Maelor Foods, Pickhill Lane, Cross Lanes, Wrexham

Variation of Condition 07 of Planning Permission APP/H6955/A/18/3216187 to Permit the Processing of 2 million Birds per Week

Introduction

From:	Chief Officer, Environment & Technical	To:	Chief Officer Planning & Regulatory
Our Ref:	ET/DC/MZ/P/2022/0820	Your Ref:	P/2022/0820 Res(1)
Date:	02/07/2024

Maelor Foods Further Development				Maelor Foods Ltd	
Site Access Visibility Splay Assessment					
DRAWN: EG	CHECKED: PW	DATE: 01.08.24	SCALES: 1:750 at A3	DRAWING NUMBER: D100	REVISION: .

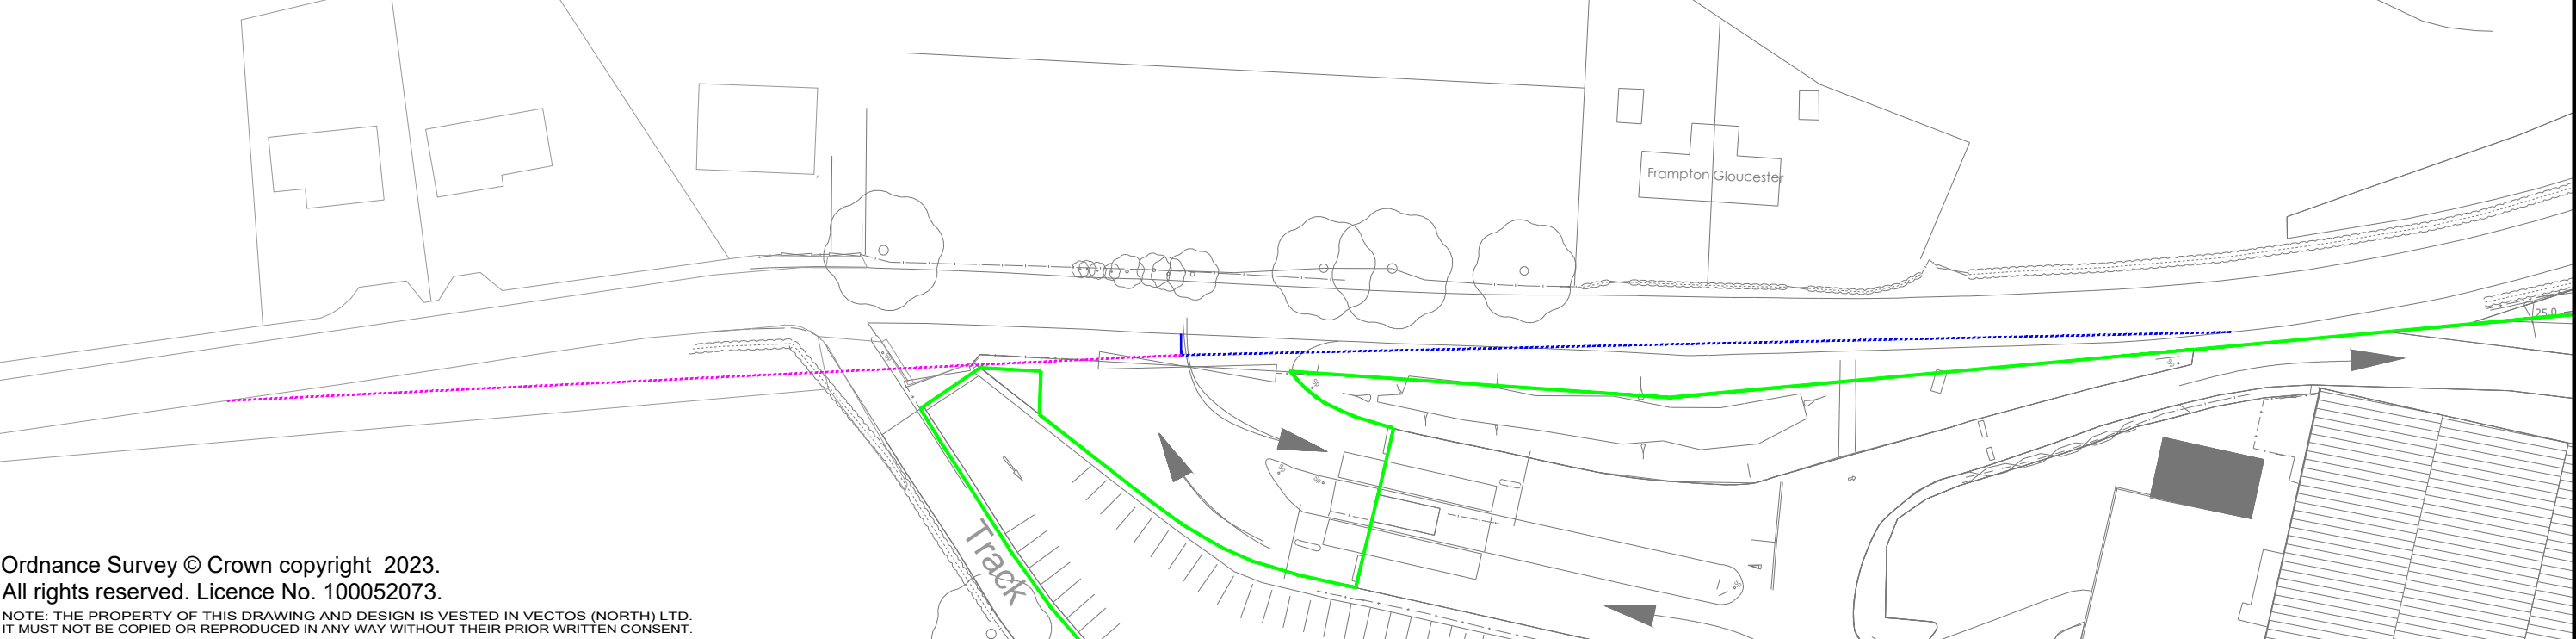
The access arrangements /gates for the general car park are also asked to be clarified as the plans do not show the operations clearly and a site visit by the LHA confirmed a different arrangement to what was previously described.

Since the most recent 2023 transport document, the access arrangements at the site have changed. Staff and visitors now access the site slightly east of the historic entry point. The photos below illustrate this new arrangement.

Visibility splays of 110m to the southwest and 121m to the northeast are provided as **Drawing 410.66138.00001_D100** and presented on the latest layout. The visibility splays conform to the distances specified in the previous highway response report.

The visibility splays will fall within land under the applicants control and all fencing etc. will not impede the required visibility splays, with the proposed acoustic barrier shown in green on **Drawing D100**.

Pickhill Lane, Wrexham				Maelor Foods Ltd	
Proposed Car Park Layout					
DRAWN:	CHECKED:	DATE:	SCALE:	DRAWING NUMBER:	REVISION:
YF	PW	17.07.2024	NTS	410.066138.00001-DR101

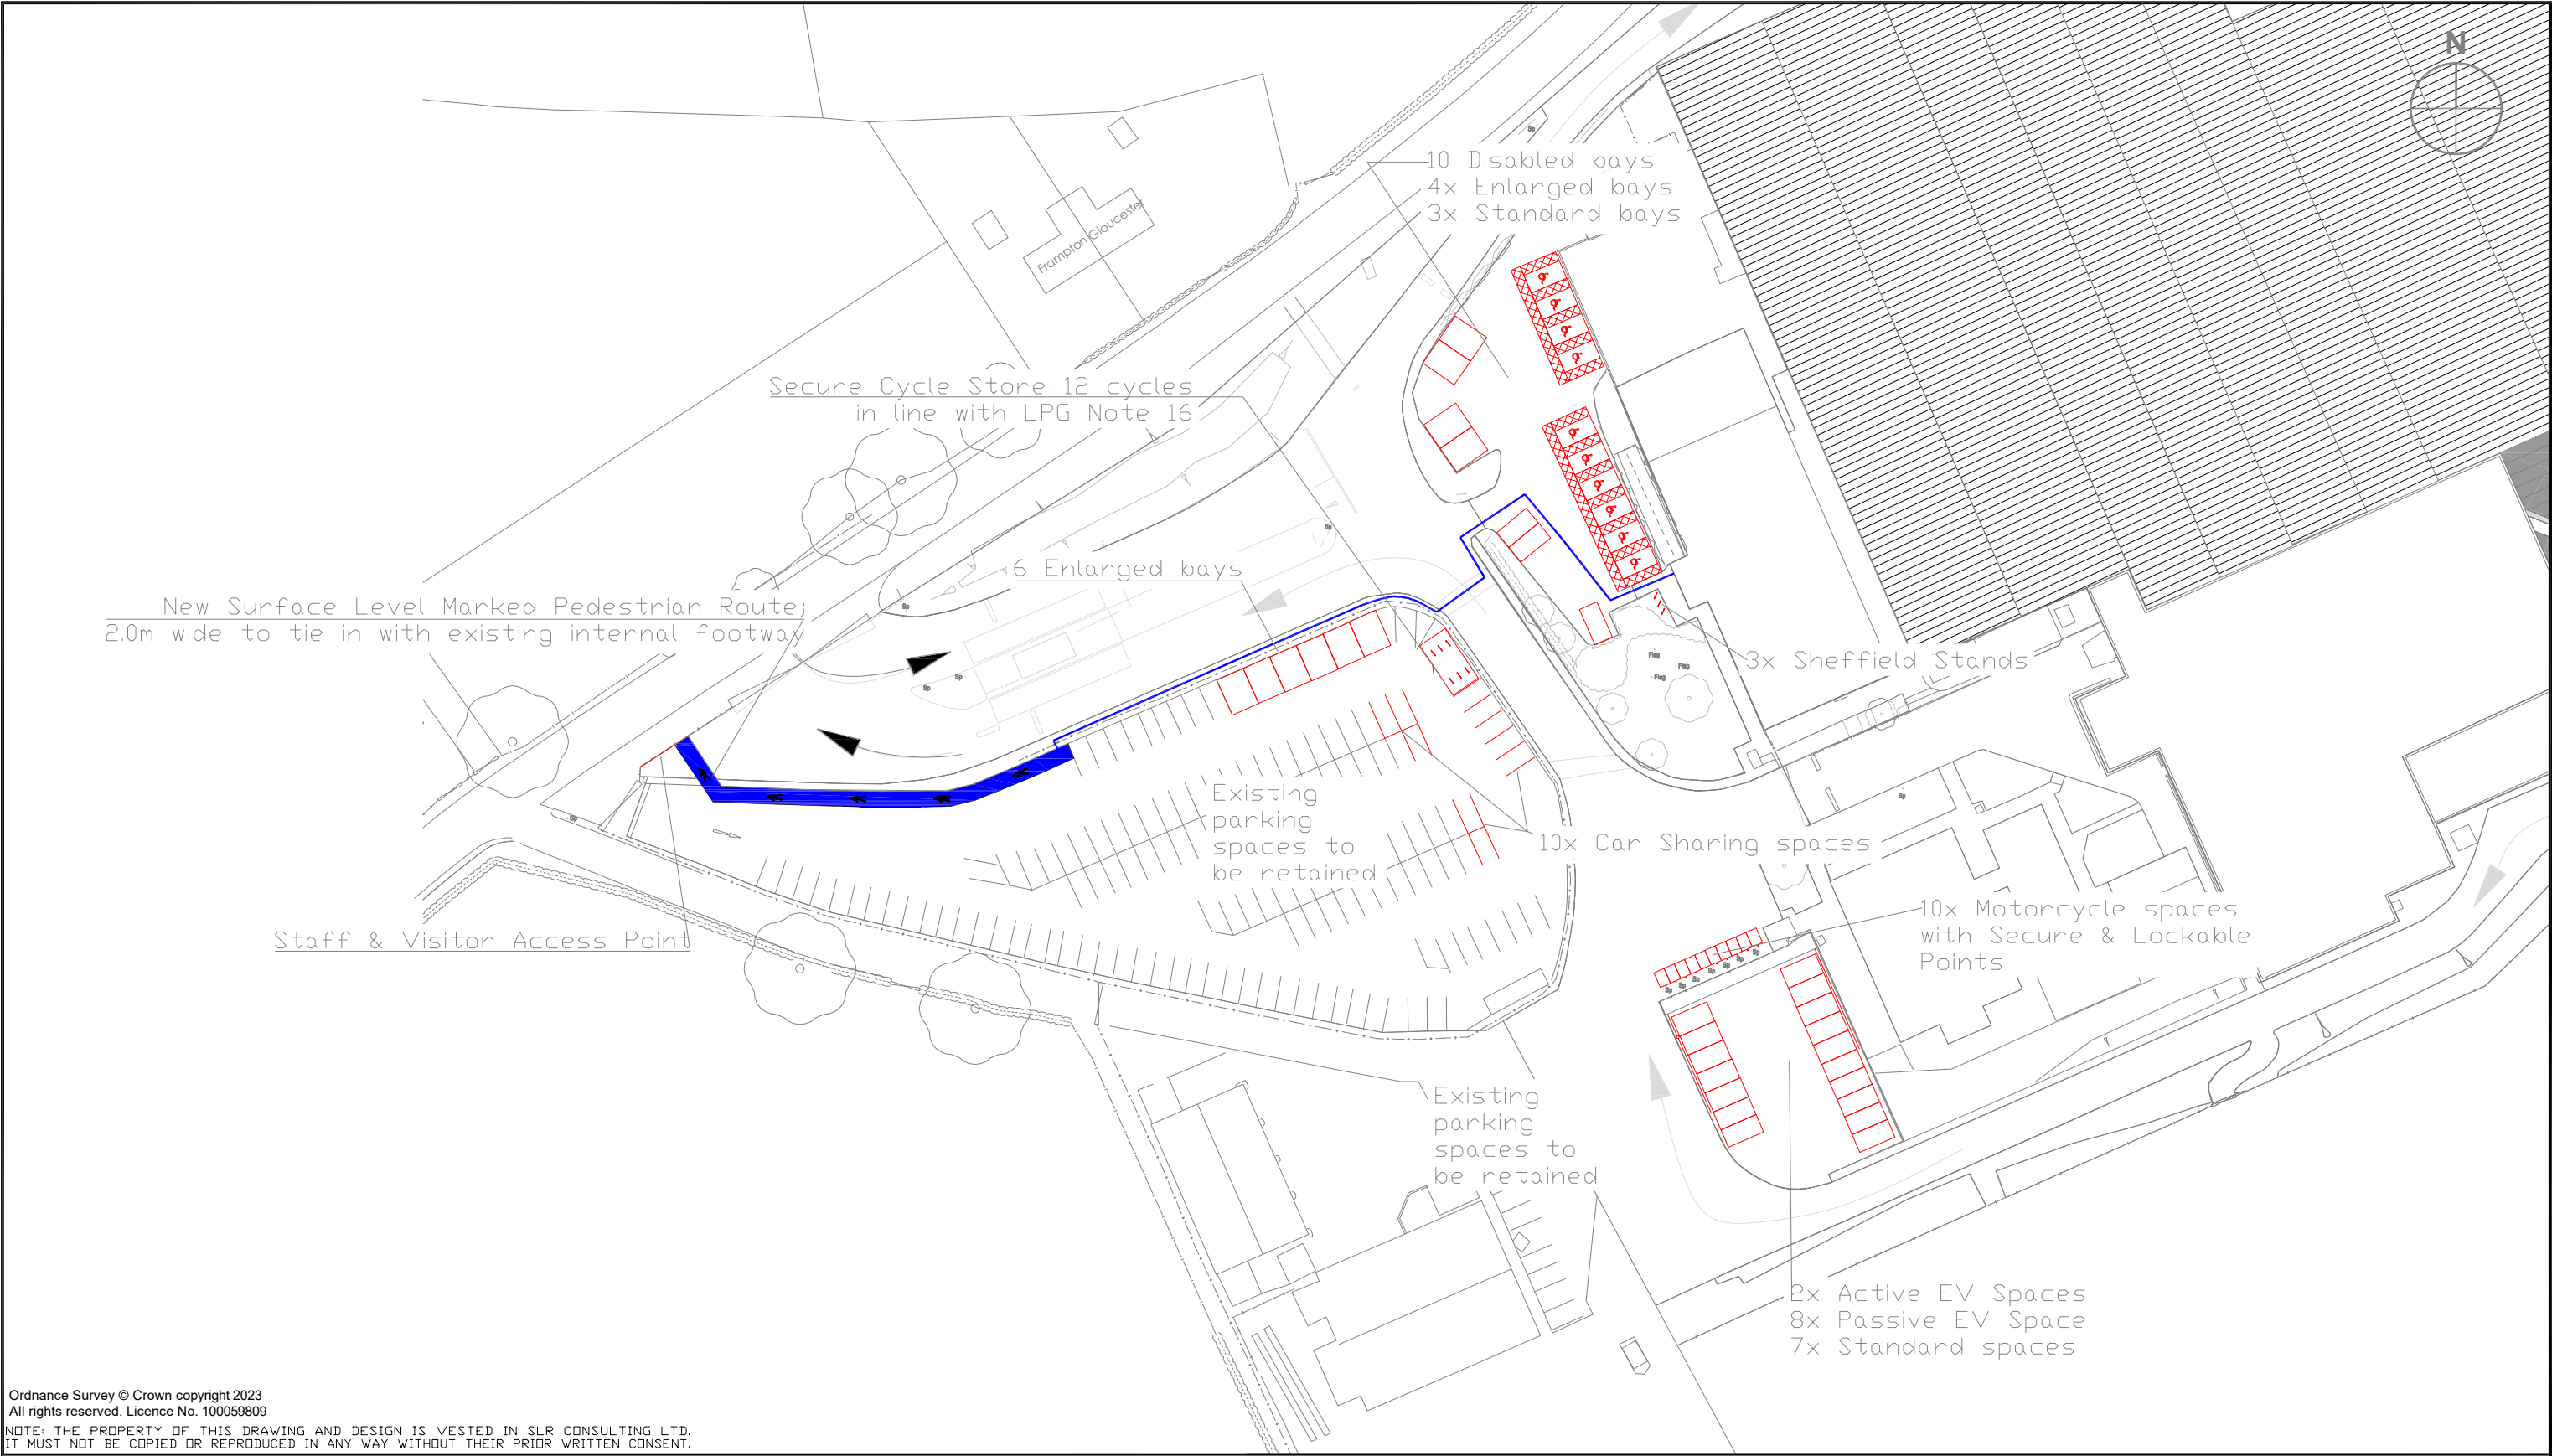
The applicant is requested to submit an updated site layout plan to detail the proposed car park layout and provide details of cycle parking, motorcycle parking, car share spaces, pedestrian access path, showers and changing facilities. The LHA cannot advise on the levels required as no floorspace has been provided within the application submission.

It is requested that further clarification of the site access arrangements and an updated site layout plan are submitted detailing the proposed car parking, disabled parking spaces, cycle parking, motorcycle parking, car share spaces, electric vehicle charging points and pedestrian path proposed within the site.

As discussed, a 2.0m wide surface-level marked pedestrian route from Pickhill Lane will be implemented. This designated route will connect with the existing internal footway in the site. **Drawing 410.66138.00001_D101** illustrates the complete pedestrian route from Pickhill Lane to the pedestrian entrance of the building.

The proposed layout of this arrangement is presented in **Drawing 410.66138.00001_D101** and will be implemented as part of the proposals.

As has been discussed above, **Drawing 410.66138.00001_D101** shows the updated site layout plan and proposed car parking layout. This layout broadly follows that of Figure 3 within the Transport Addendum. The proposed modifications of the car park bring the total on-site car parking provision to circa. 215 spaces.
